Access Compliance Report

Public Rights-of-Way

Intersection ID: 12435	Main Street: ALLEN_ST	Cross Street: PEGRAM_ST	Location: S
ADA ID: 7884235CE444	Ramp Type: BlendTrans1	Initial Pass/Fail: Fail	Overall Compliance: No
			Severity Score: 18.75

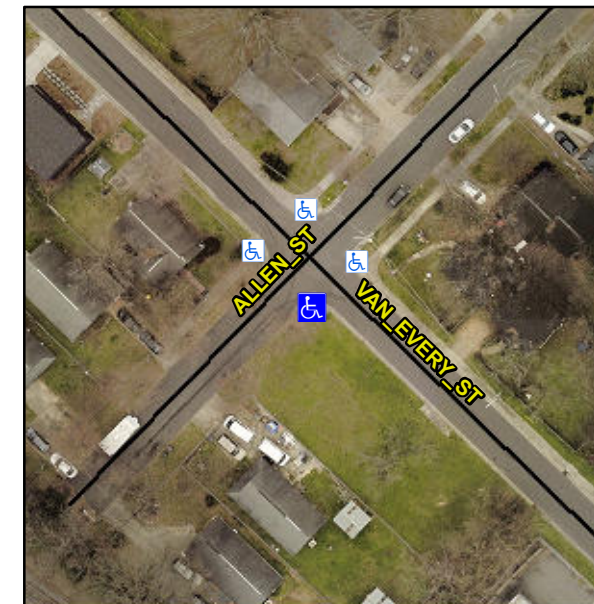
NO SWs

Not Found, R304.5.1, R304.5.3

Remove & Replace Curb Ramp With Two New Directional Ramps or Equivalent.
